COMMENTS ON THE PROPOSAL FOR A GTR ON MOTORCYCLE CONTROLS,
TELL-TALES AND INDICATORS

Note: The text reproduced below was prepared by the expert from the European Commission in order to give comments on informal document GRSG-96-34 as well as document ECE/TRANS/WP.29/2006/74 which has served as the basis of the Commission's remarks. The European Commission wishes to note that all efforts made to achieve a Global Technical Regulation regarding this subject are regarded as very welcome.

Brake:

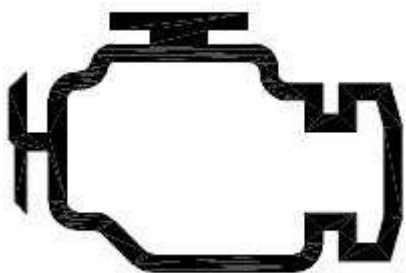
Also the following optional symbol for any other braking failure (Red) should be added:

JUSTIFICATION: This is the universal symbol for general braking failure (other than ABS failure) and should therefore be added (i.e. not a required function, but to be used if such tell-tale is present). [It is a requirement in gtr #3 to have a tell-tale for brake failure.](#)

Emissions related Malfunction Indicator Lamp (Yellow)

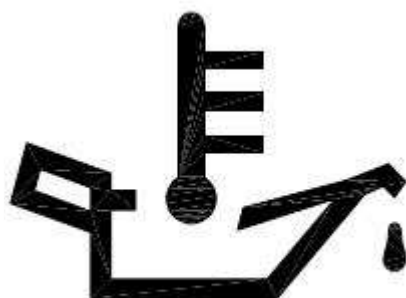
This (or any similar) symbol shall not be used to convey non-emissions related failures or operation states.

JUSTIFICATION: An emissions related error is not dangerous and therefore the colour of the tell-tale should not be red. Such MILs are already widely used and vary between different manufacturers. The Commission's opinion is that this symbol should be added. [OK](#)

Symbols for further consideration

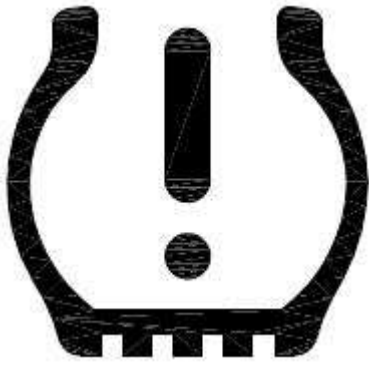
"If _____ fitted, it shall be identified by the given symbol:" [Are symbols listed in the gtr mandatory or optional?](#)

Oil temperature (Red)

Vehicle speed control (Yellow or Green)

Tyre pressure (Yellow or Red)

Service (reminder) indicator (Yellow)

JUSTIFICATION: For further harmonization purposes.
